PASADENA WATER AND POWER

SUBJECT: National Aeronautics and Space Administration (NASA), Jet Propulsion Laboratory (JPL) Technical Memorandum (TM): Additional Investigation Results, January 31, 2007

Review and Comments of NASA's Jet Propulsion Laboratory 31-Jan-07 Technical Memorandum: Additional Investigation Results

REVIEW AND COMMENTS OF NASA'S 31-JAN-07 JET PROPULSION LABORATORY TECHNICAL MEMORANDUM: ADDITIONAL INVESTIGATION RESULTS

Figure 25

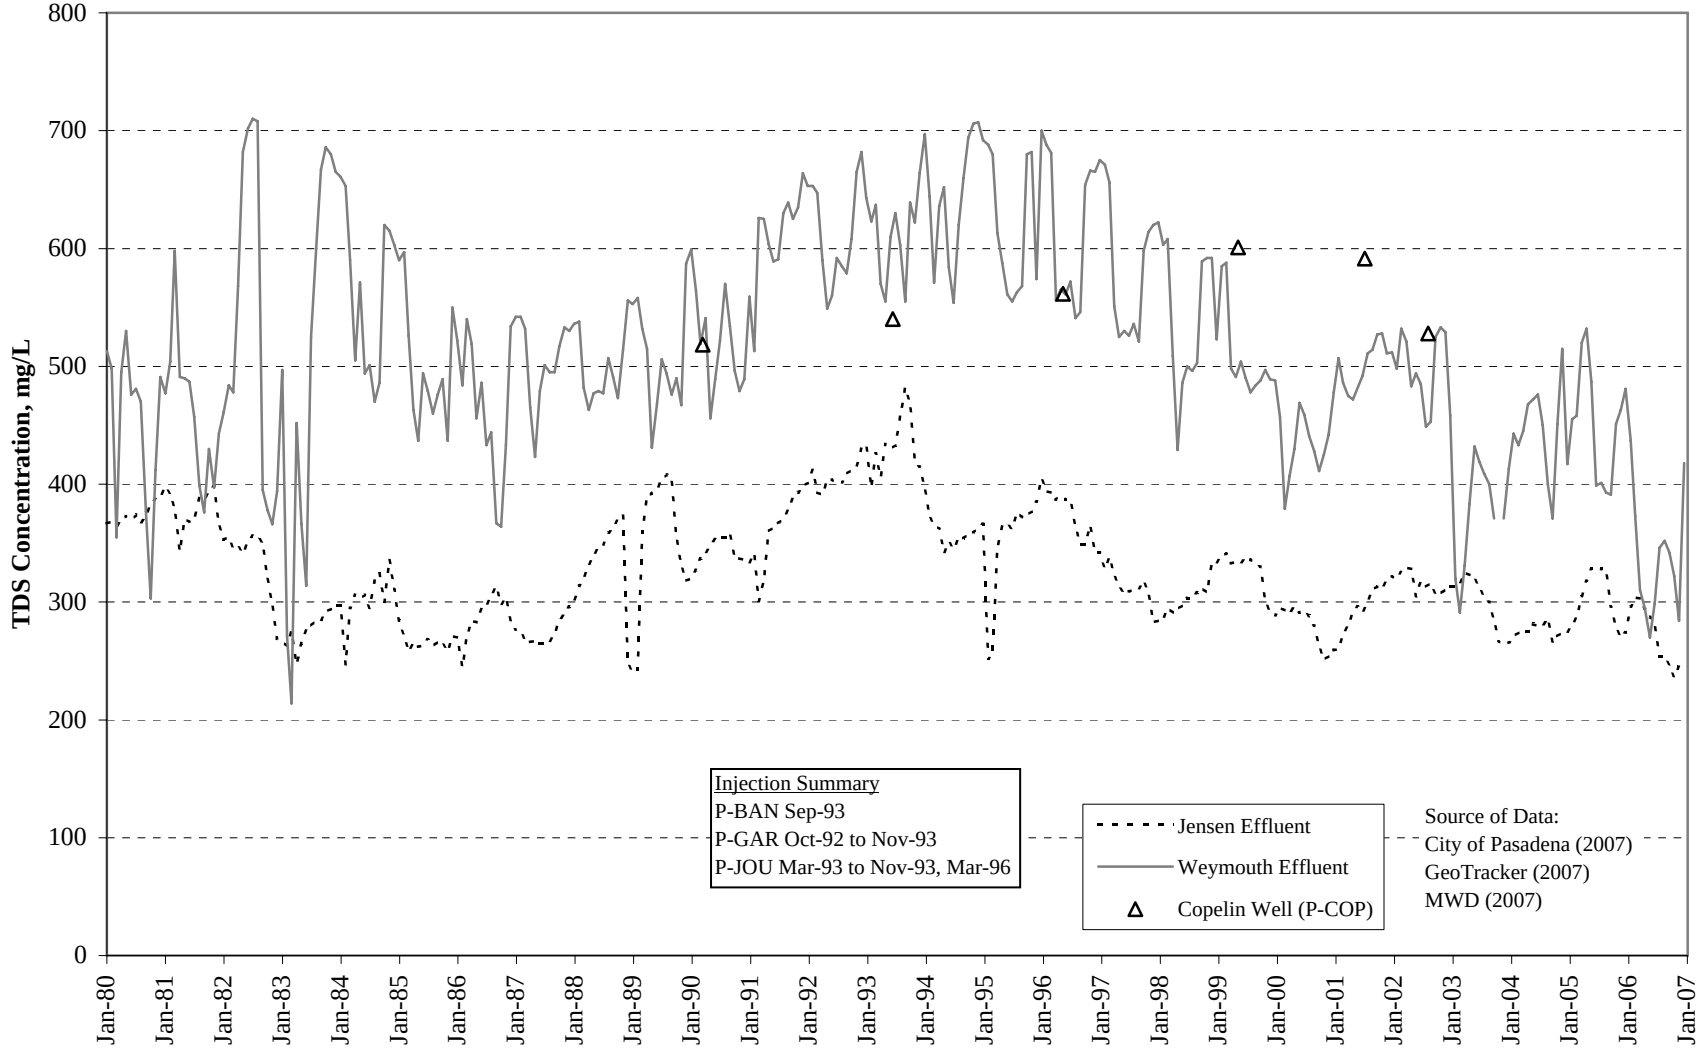
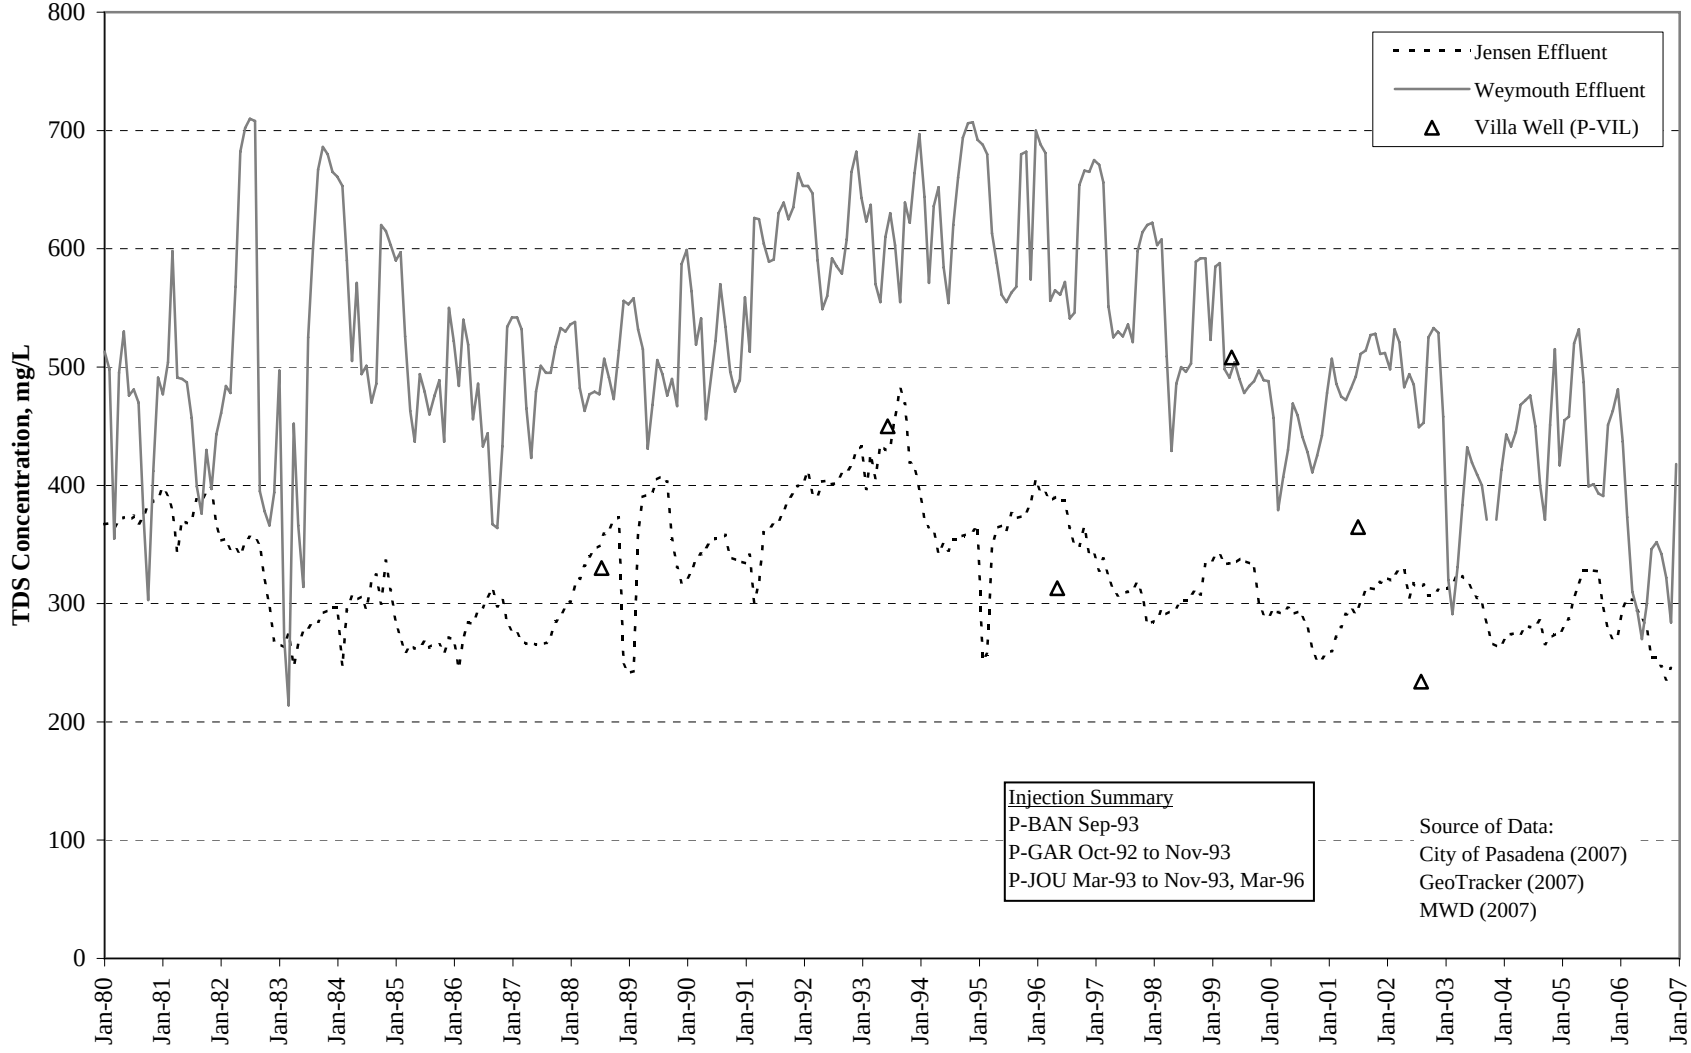
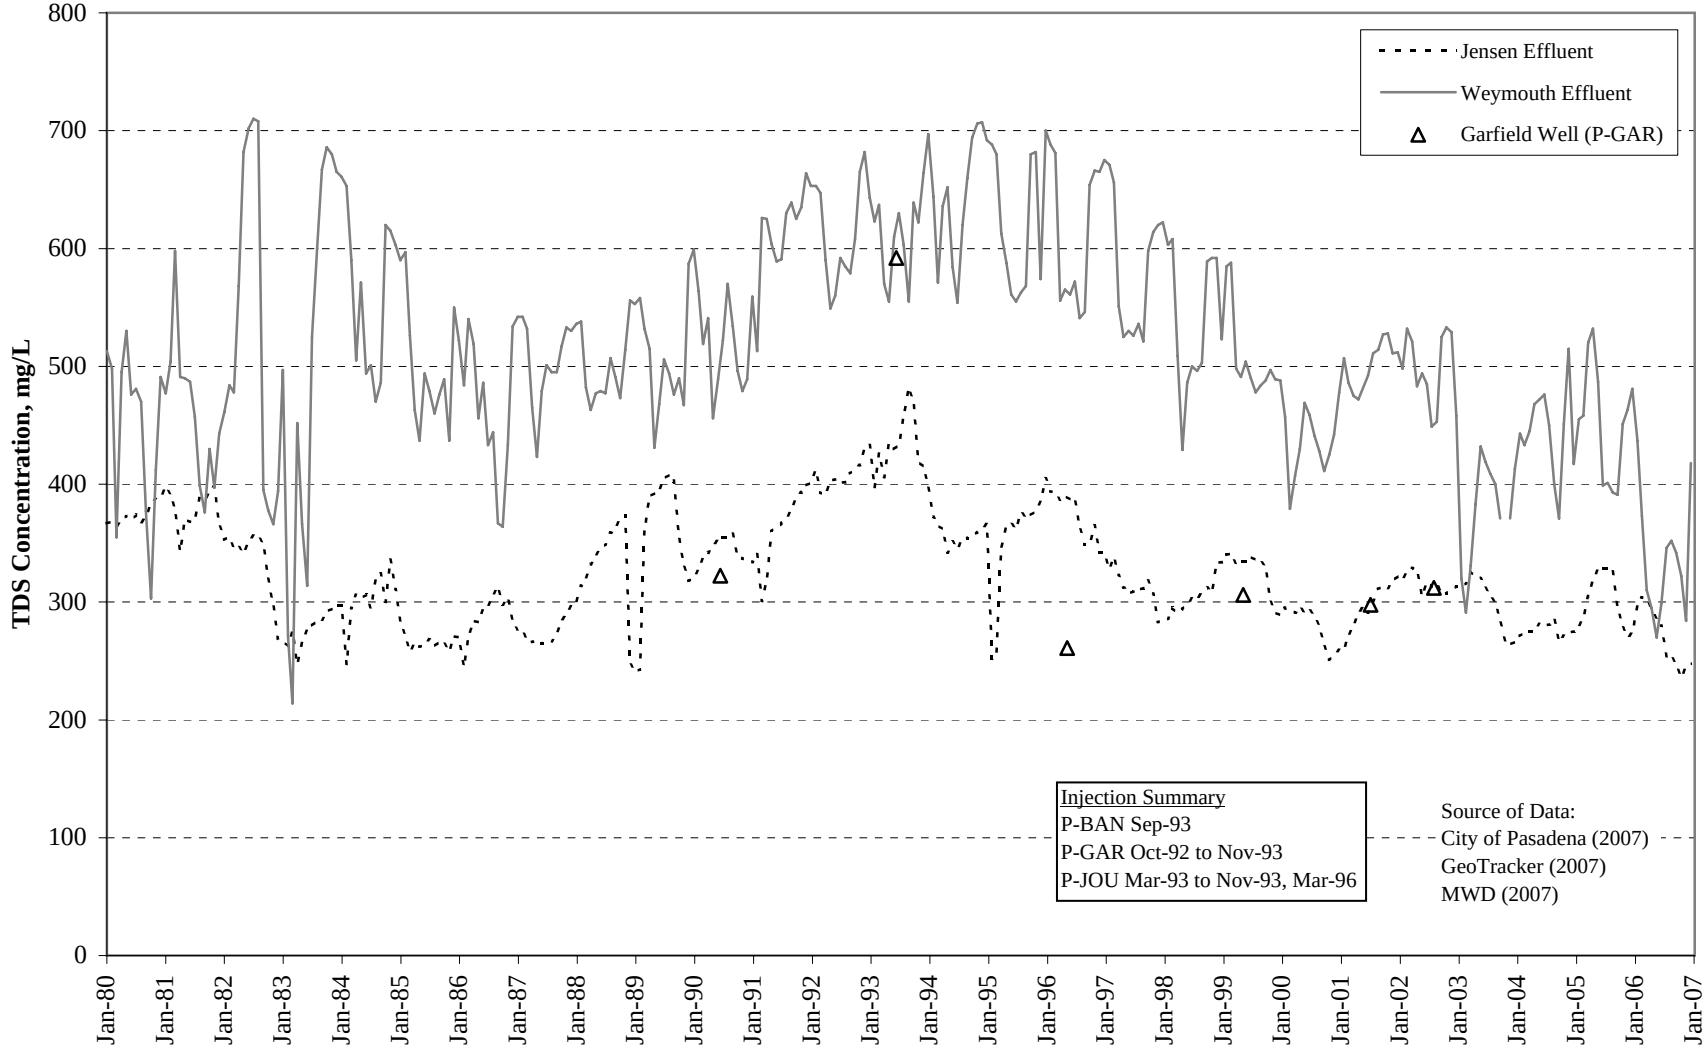
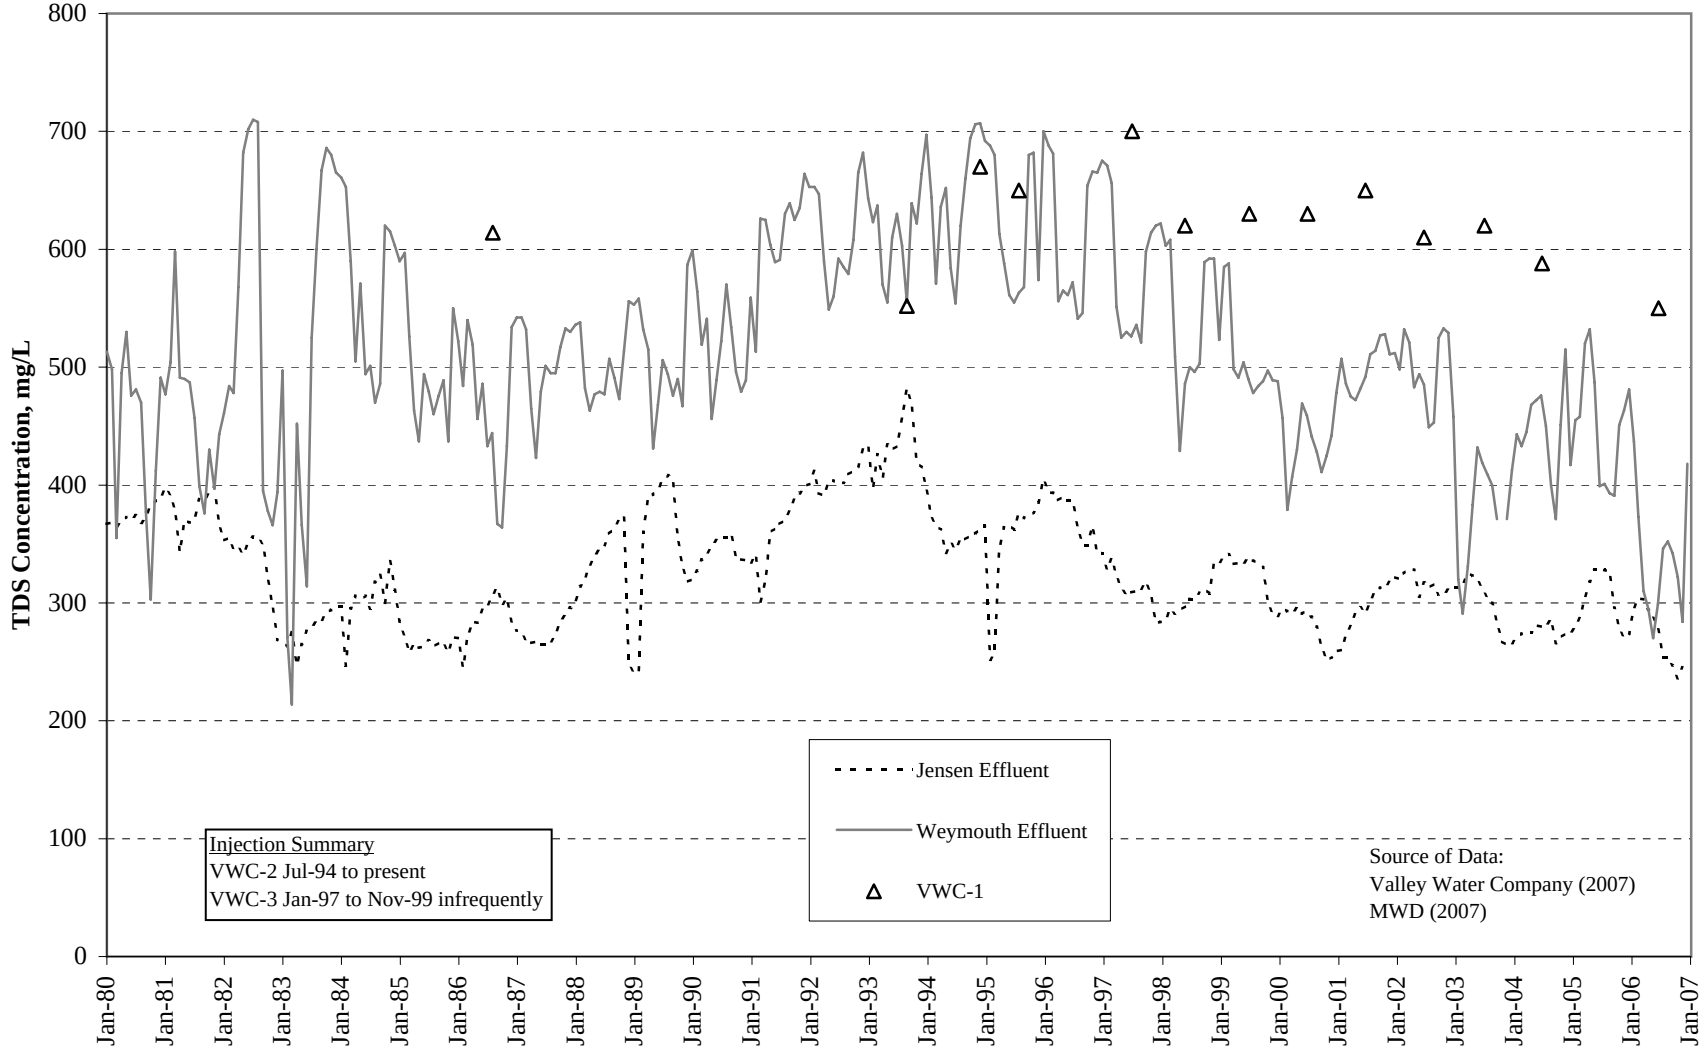
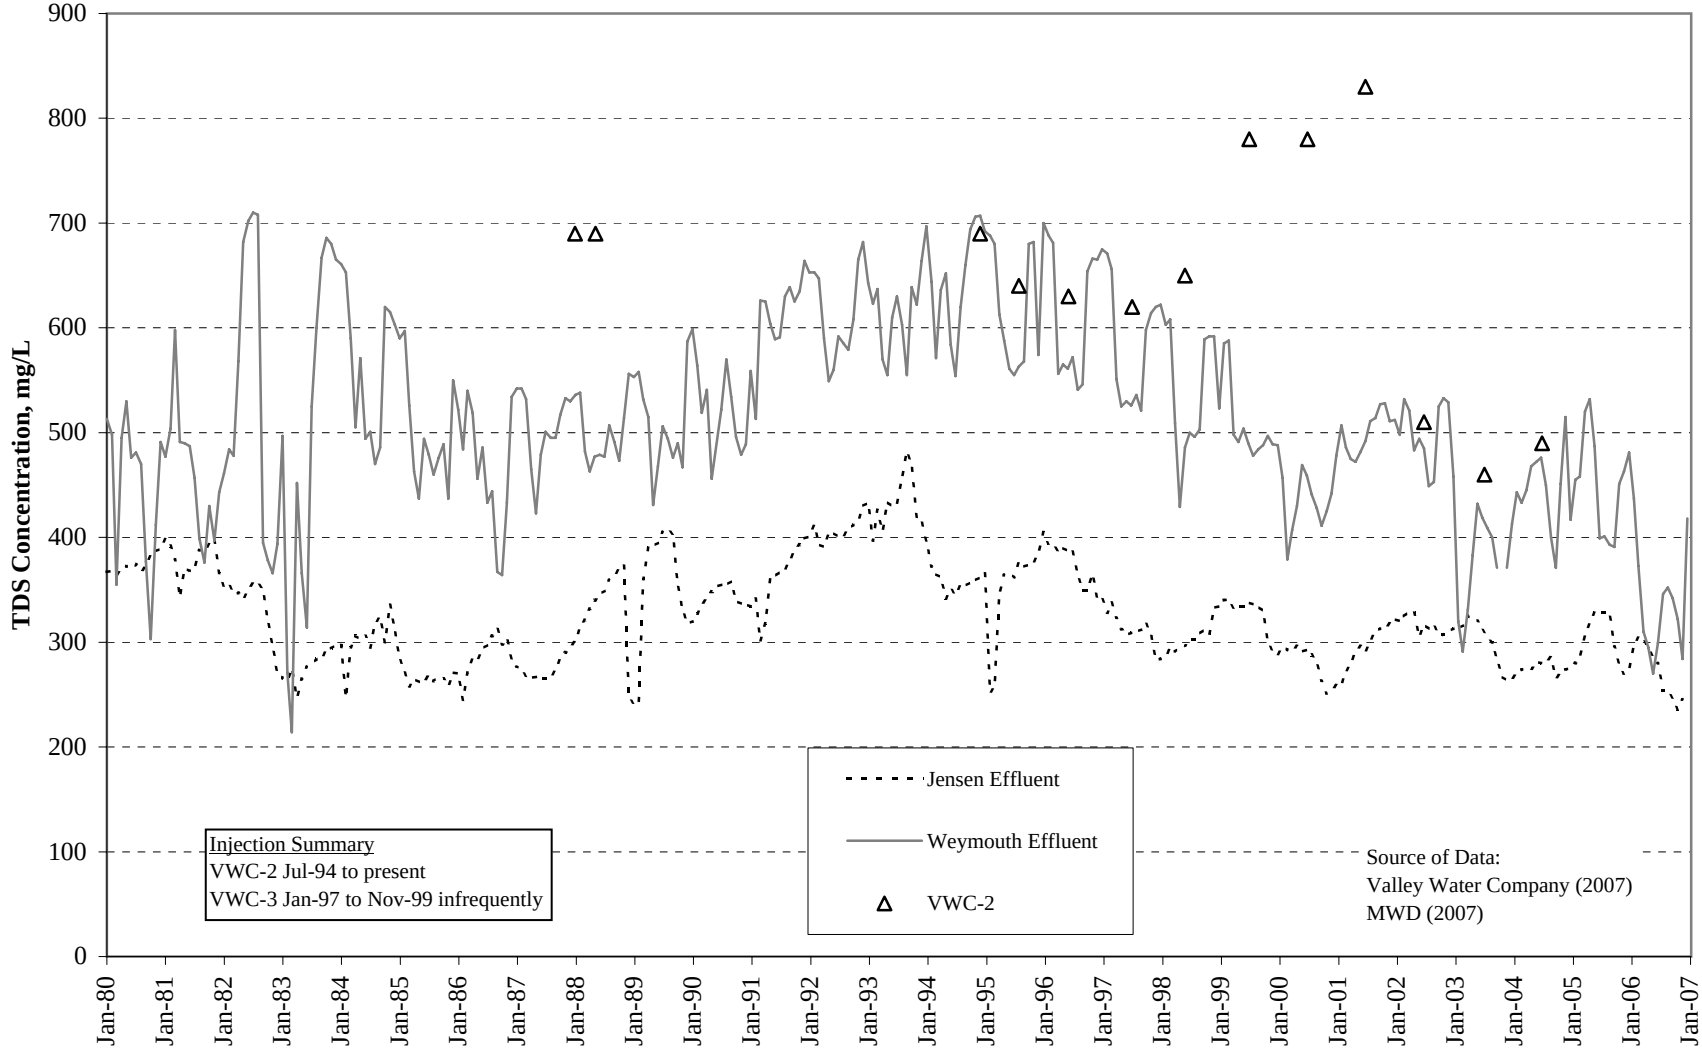
It is agreed that sulfate in the Basin has increased in some areas, possibly due to the importation of Colorado River Water and recharged as return flow including septic tank discharge in unsewered areas. Also, in the Sunset Reservoir and Valley Water Company wells, historical sulfate trends show a range of increases, no changes and decreases as shown in Figures 5 – 31, and summarized in Table 1.

If the mechanism described by NASA for concentrating perchlorate in the ground water to levels above the source/recharge water was valid, it would be expected that other salts, such as sulfate, chloride and TDS would also increase in the ground water to concentrations exceeding the recharge water. Figures 5 through 13 show that sulfate in ground water (both Sunset Reservoir area and Valley Water Company wells) have mostly remained at or below imported Colorado River and State Project water concentrations, while Figures 32 through 36 show perchlorate in ground water significantly higher than concentrations in imported water for wells hydraulically downgradient of the JPL facility.
